## APPENDIX C

### TECHNICAL MEMOS

Technical Memo #1 Landslide Mapping Accuracy and Modelling

<b>To:</b>	Teri Camery (CBJ)	<b>Date:</b>	April 27, 2022
<b>c:</b>	Alix Pierce (CBJ)	<b>Memo No.:</b>	1
<b>From:</b>	Rita Kors-Olthof, Vladislav Roujanski, Shirley McCuaig	<b>File:</b>	704-ENG.EARC03168-01 / 704-ENG.EARC03168-02A
<b>Subject:</b>	Landslide Mapping Accuracy and Modelling Downtown Juneau Landslide and Avalanche Hazard Assessment

**Figure 1: Excerpts from Figure 2.2c Avalanche Path Mapping Detail (Figure 1A) and Figure 2.3a Avalanche Hazard Designation Mapping Overview (Figure 1B).**

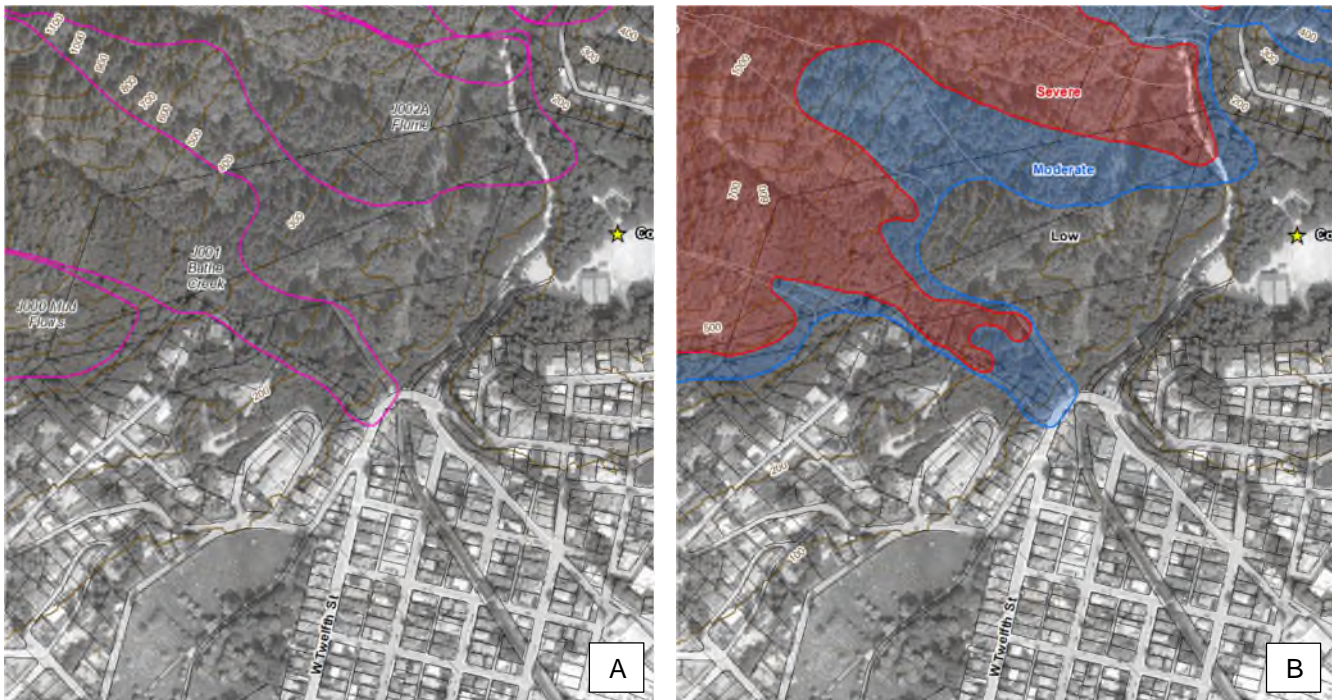
**Response:** In several instances, the apparent odd shapes of some of the terrain units result from the shapes of the adjacent terrain units. One example is the Bathe Creek drainage above Irwin Street and Gold Creek, where the shape of the east edge of the colluvial cone/fan is affected by an area of bedrock (shown in purple and marked Rr/Cv on Figure 1.3b). Immediately upslope of the bedrock area is another area of colluvium marked Ca|dr that apparently encroaches into the Bathe Creek drainage. So, even though the Bathe Creek fan/cone looks a little odd on the east side, the adjacent landforms are the cause of this peculiar boundary (see excerpts of the figures in Item 6 below).

**Response:** See response to Item 3 above regarding the irregular “curlicues and “projections.” Bathe Creek is an example of where adjacent terrain units affect the shape of this terrain unit. In general, because the processes are not the same, avalanche path boundaries should not be expected to match landslide hazard boundaries. Compare the excerpts from the avalanche path and hazard mapping in Figures 2.2c and 2.3a (Figure 1 below) with the surficial geology and major gully features in Figures 1.3b and 1.5b (Figure 2 below). The boundaries of wet avalanches might sometimes approximate the boundaries of debris flows in the same terrain feature, a resemblance that would necessarily depend on the size and mobility of each event. In this case, they could be similar but not identical.

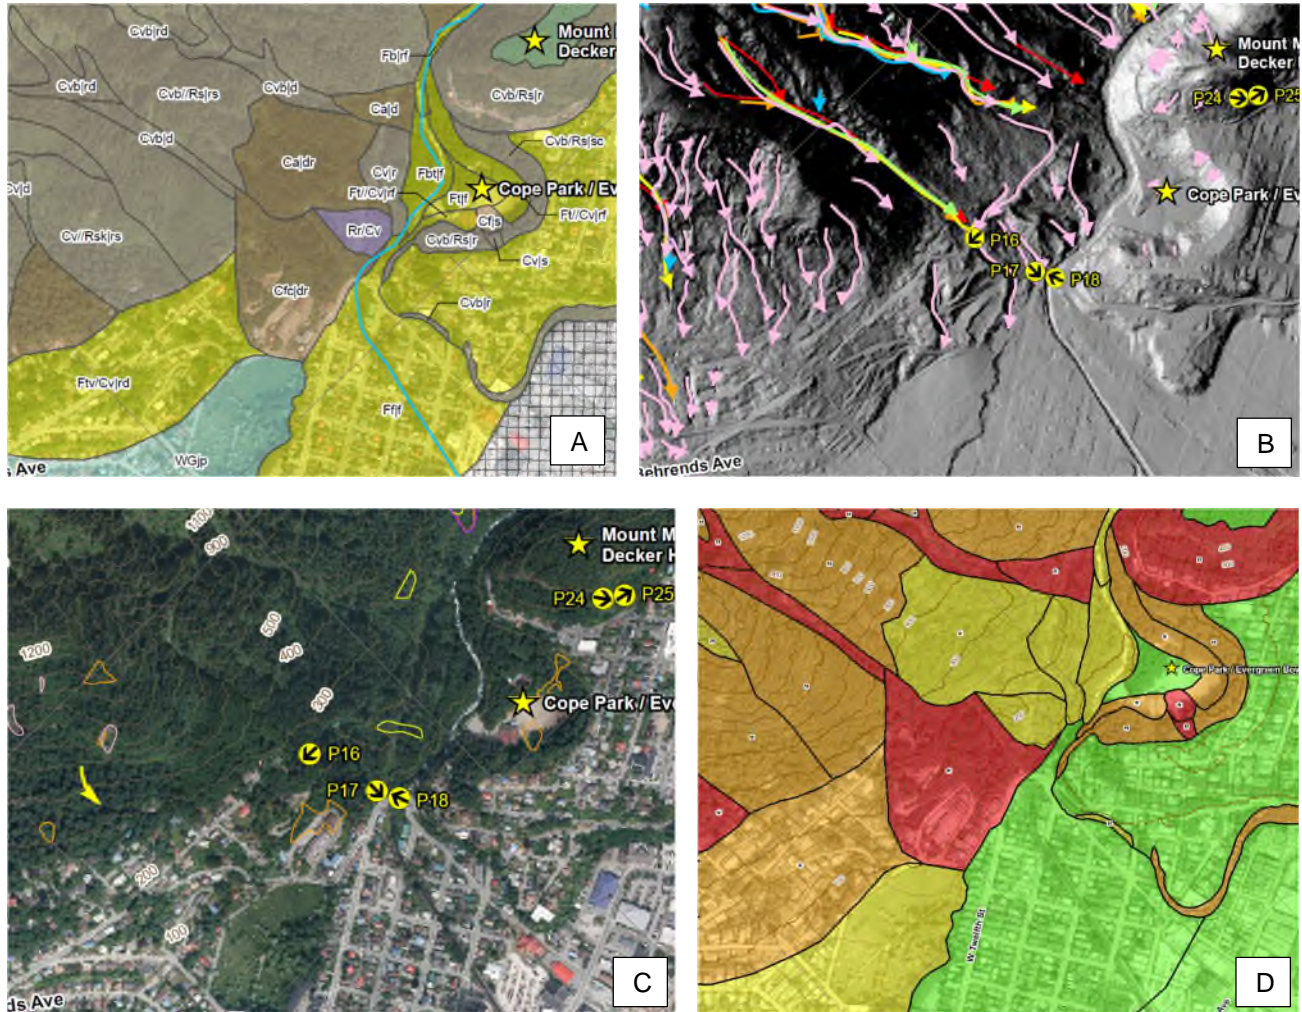
7. **Question/Comment:** Swanson’s study seems to indicate that flow from Bathe Creek was turning sharply enough to make that south and west area part of the runout, either when he did his 1972 study, or in the recent past. But the topography at the mouth of the Bathe Creek canyon is now incised enough that it would take a major change to divert it south and west again. This mapping is supposed to be for current conditions and topography, not speculation on how it might change in the future.

Compare the surficial geology and the major gully features shown in excerpts from Figures 1.3b and 1.5b (Figures 2A and 2B below). In the case of Bathe Creek, the shape of the *Severe* area reflects the shape of the cone/fan and the upslope gully that is the source of the debris, as shown below in the excerpt from Figure 1.6c (Figure 2D). Finally, even though the fan itself only displays occasional activity (remobilization of old debris flow material), as shown in the excerpt from Figure 1.4b (Figure 2C), the debris flows originating from upslope govern the hazard designation, as they are what has formed the fan and what will continue to do so in the future.
